Griffith Avenue Group is a group of residents living on a stretch of the avenue from Grace Park Road to Calderwood Road. We wish to appeal the decision of Dublin City Council that a cycleway proposed for Griffith Avenue, Dublin is exempted development.

**Feasibility Report for installing a cycleway along Griffith Avenue, between
Drumcondra Road to Charlemont Estate**

Griffith Avenue – Phase 2 Segregated Cycle Lanes

Stage 3 Road Safety Audit

PARKING SECTION DETAIL

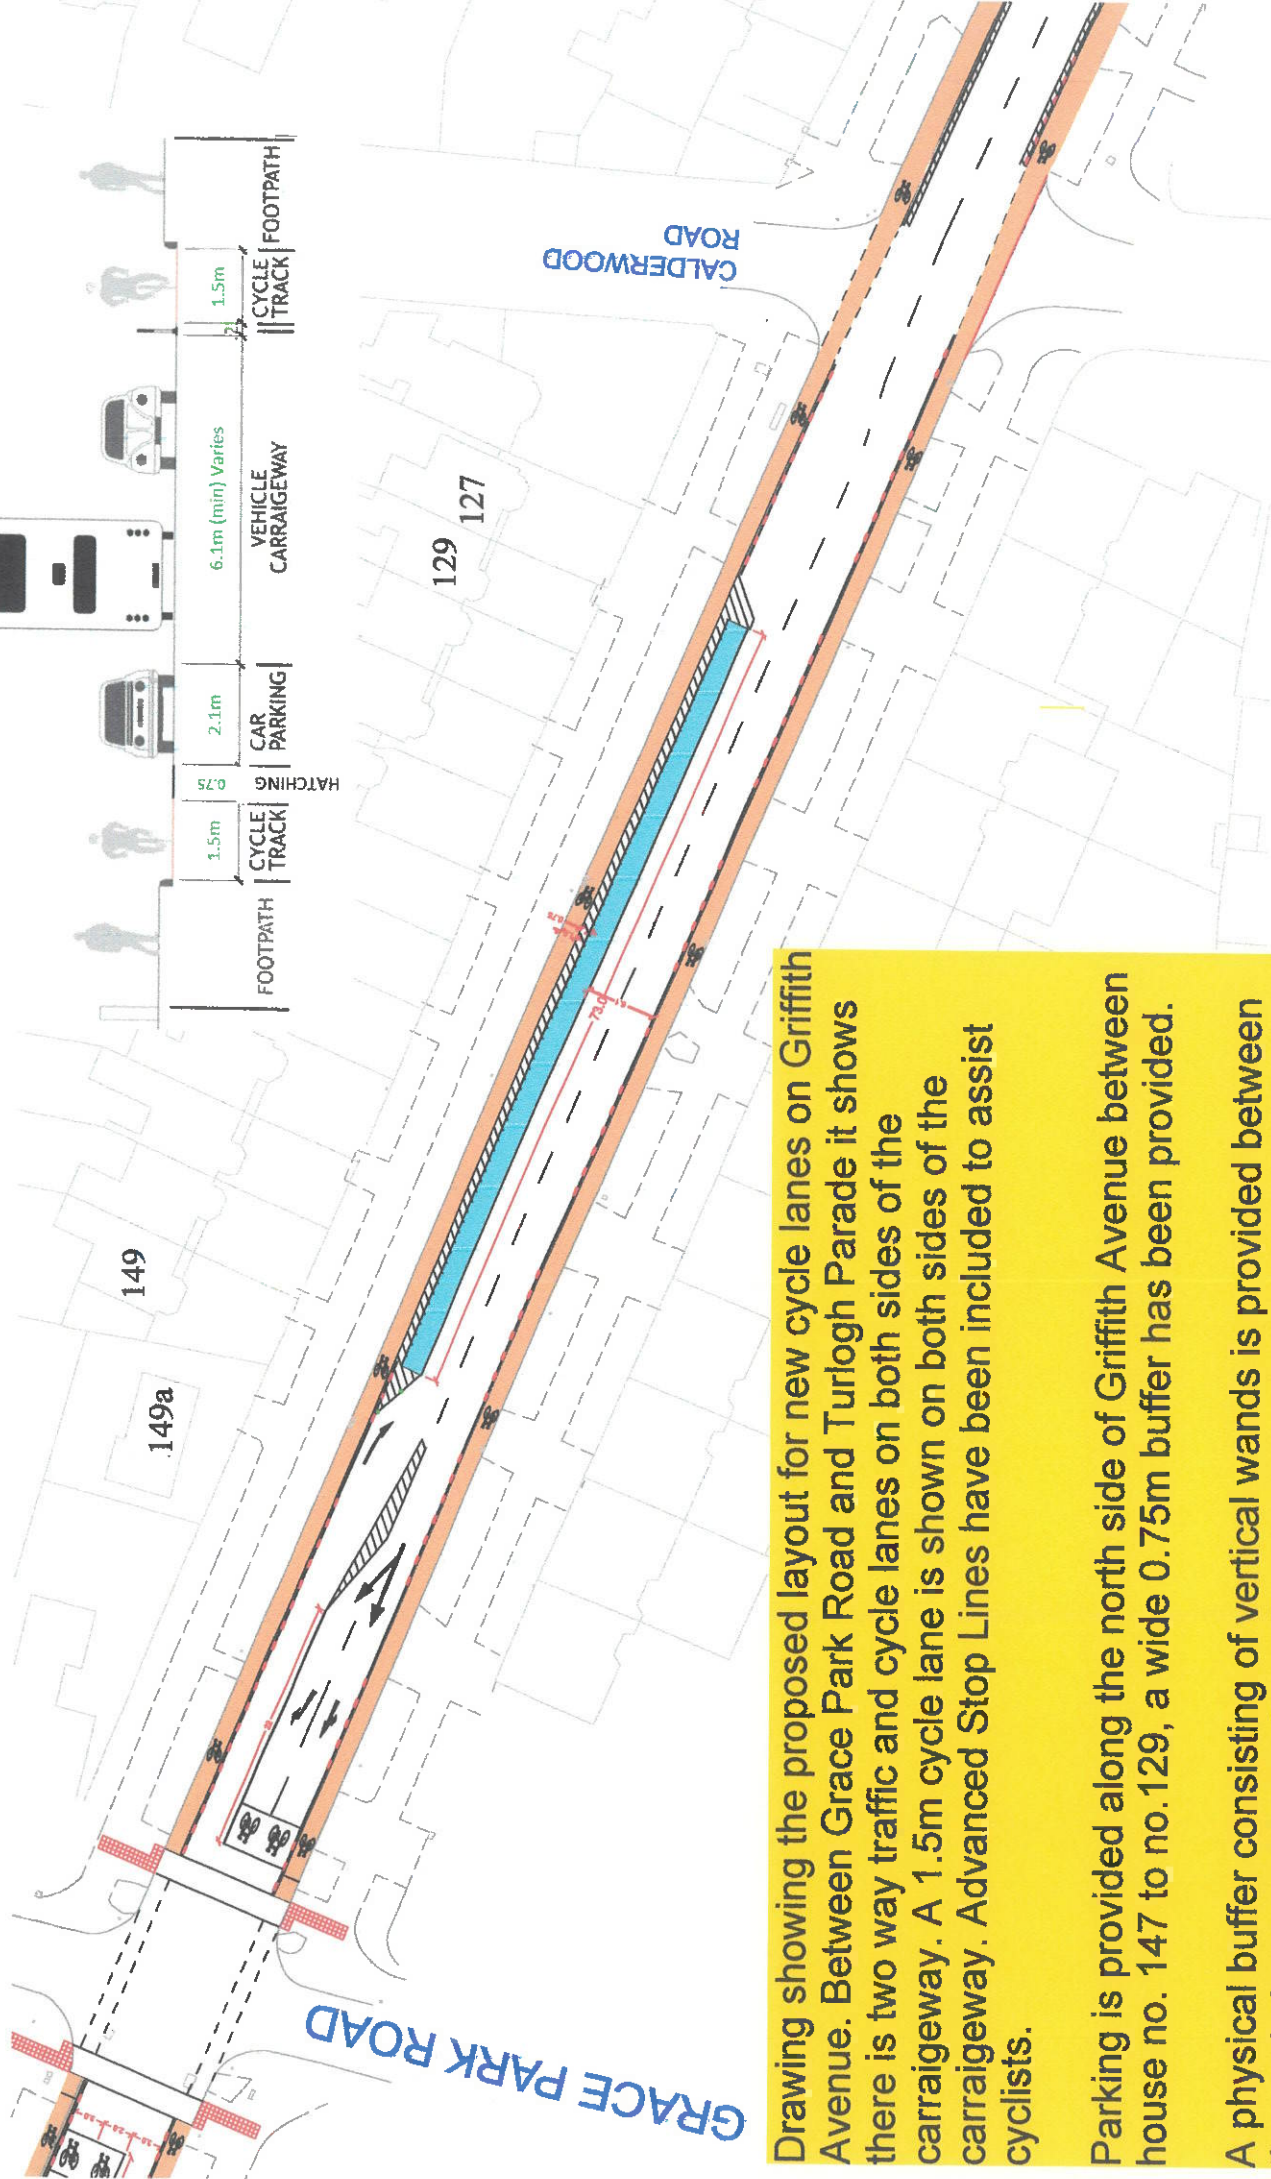
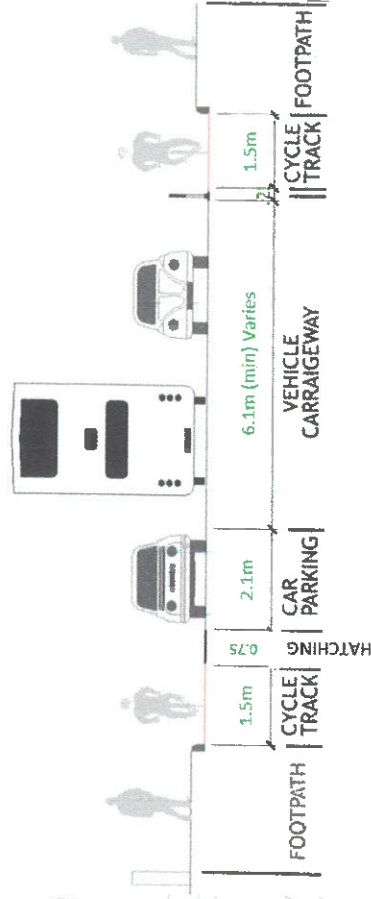
On the stretch of the avenue from Grace Park Road to Calderwood Road the layout includes cycle lane on both sides of the carriageway of 1.5m. A parking bay of 1.8m wide has been included in the design on the north side of the avenue from house no.147 to no.129 with a buffer between the bay and the cycle lane of 0.75m. The vehicle carriageway is reduced to 6.1m.

- 1) The proposed parking bays are so far out on the road they will cause a hazard to passing traffic when residents are getting in and out of their vehicles.
- 2) Older and disabled residents, in particular, will struggle to get in and out of their cars. Some of the residents are in their 80s and 90s with impaired mobility. They will be attempting to get into cars as traffic passes them at up to 50km per hour on what will now be a narrow carriageway.

- 4) Cyclists making use of the cycle lanes will be endangered by car doors being opened into what is a very narrow buffer space of .75m between the park bays and the cycle lanes.

Figure 4.6 – Ponding the Chamber Cover

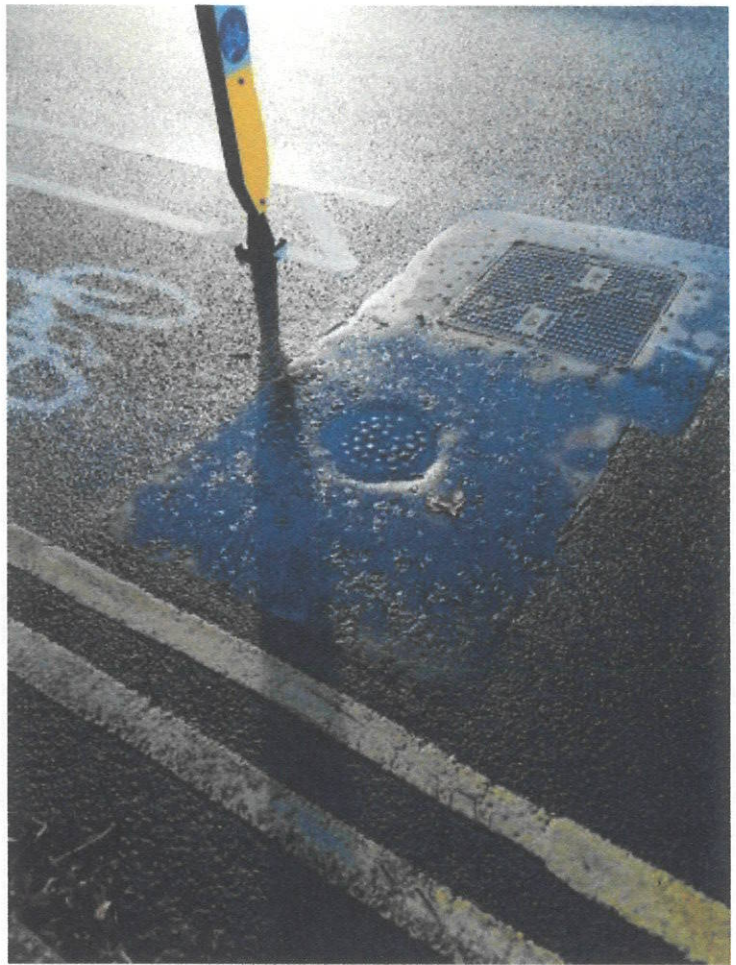
Description:

Ponding was noted in one of the chambers at the western end of the scheme on the northern side. If ponding was to build up in the cycle lane and freeze there is a risk that cyclists could skid on it, falling off their bike onto the vehicle carriageway, resulting in a collision.

Recommendation:

The chamber lid should be raised to ensure that ponding does not occur at this location.

4.5.1	Yes	No		It should not be necessary to raise this chamber. We intend on surfacing the entire cycle lane with a buff anti-skid and this should take care of any ponding issue.
